**STATE OF DELAWARE
EXECUTIVE DEPARTMENT
OFFICE OF STATE PLANNING COORDINATION**

RE: PLUS review 2015-7-02; Summit Point

Thank you for meeting with State agency planners on July 22, 2015 to discuss the proposed plans for the Summit Point development. According to the information received, you are seeking review of a 99 unit subdivision on 189.6 acres in New Castle County.

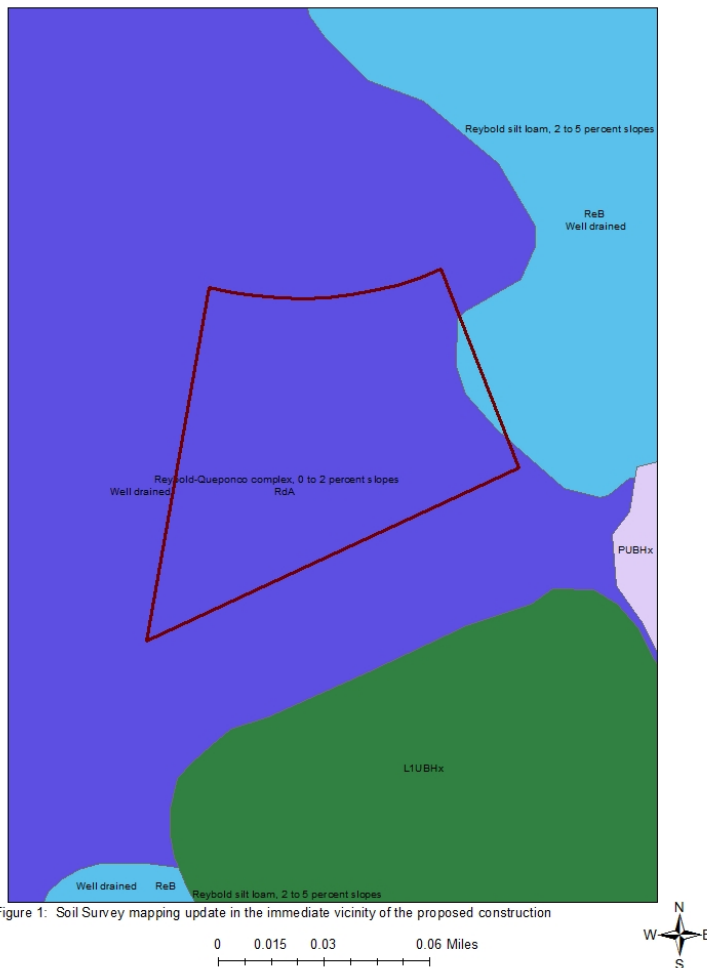
- The soils on this parcel consist mostly of well-drained upland soils that, generally, have few limitations for development (Figure 1). However, poorly-drained Othello (OtA) and Fallsington (FgA) are mapped in the northeastern and southwestern portions of subject parcel, respectively. Both OtA and FgA soil mapping units have severe limitations for development and should be avoided.
